# Access Compliance Report

## Public Rights-of-Way

### (Curb Ramps)

Intersection ID: 42554	Main Street: ENEIDA_SUE_DR	Cross Street: TODDVILLE_RD	Location: S
ADA ID: 73708BCC2E03	Ramp Type: Perp	Initial Pass/Fail: Fail	Overall Compliance: No
Severity Score: 12.5			
Codes/Mitigation Info/Possible Solution		Field Measurements/Component Compliance

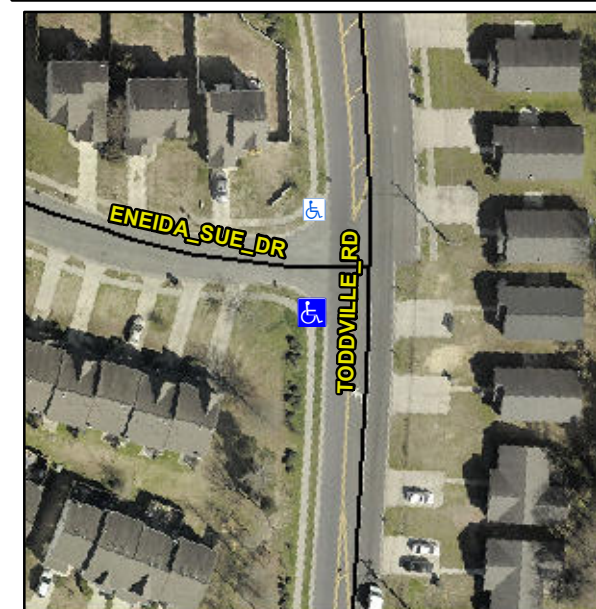
**Not Found, R304.2.2**

Compliance	Description	Data	Compliance	Description	Data
N/A	Ramp Length (in)	48.5	No	Ramp Slope (%)	8.7
Yes	Ramp Width (in)	49.5	Yes	Ramp XSlope (%)	1.4
N/A	Flare Type LT	N/A	N/A	Flare Type RT	N/A
N/A	Flare Slope LT (%)	N/A	N/A	Flare Slope RT (%)	N/A
N/A	Flare Traversable LT?	N/A	N/A	Flare Traversable RT?	N/A
N/A	Landing Length (in)	N/A	N/A	DWS Provided?	N/A
N/A	Landing Width (in)	N/A	N/A	DWS Contrast?	N/A
N/A	Landing Slope (%)	N/A	N/A	DWS Length (in)	N/A
N/A	Landing X Slope (%)	N/A	N/A	DWS Full Width?	N/A
N/A	Landing Curb? (Y/N)	N/A	N/A	DWS Offset (in)	N/A
N/A	Shared Landing?	N/A			
N/A	Gutter Ponding?	N/A	N/A	Gutter Slope (%)	N/A
N/A	Gutter Lip Ht (in)	0.5	N/A	Gutter X Slope (%)	N/A
N/A	Painted X Walk1?	No	N/A	Painted X Walk2?	N/A
	X Walk 1 Direction	To N		X Walk 2 Direction	N/A
N/A	X Walk 1 Width (in)	N/A	N/A	X Walk 2 Width (in)	N/A
	X Walk 1 Slope (%)	0.2		X Walk 2 Slope (%)	N/A
	X Walk 1 X Slope (%)	3.9		X Walk 2 X Slope (%)	N/A

**Remove & Replace Entire Ramp.**
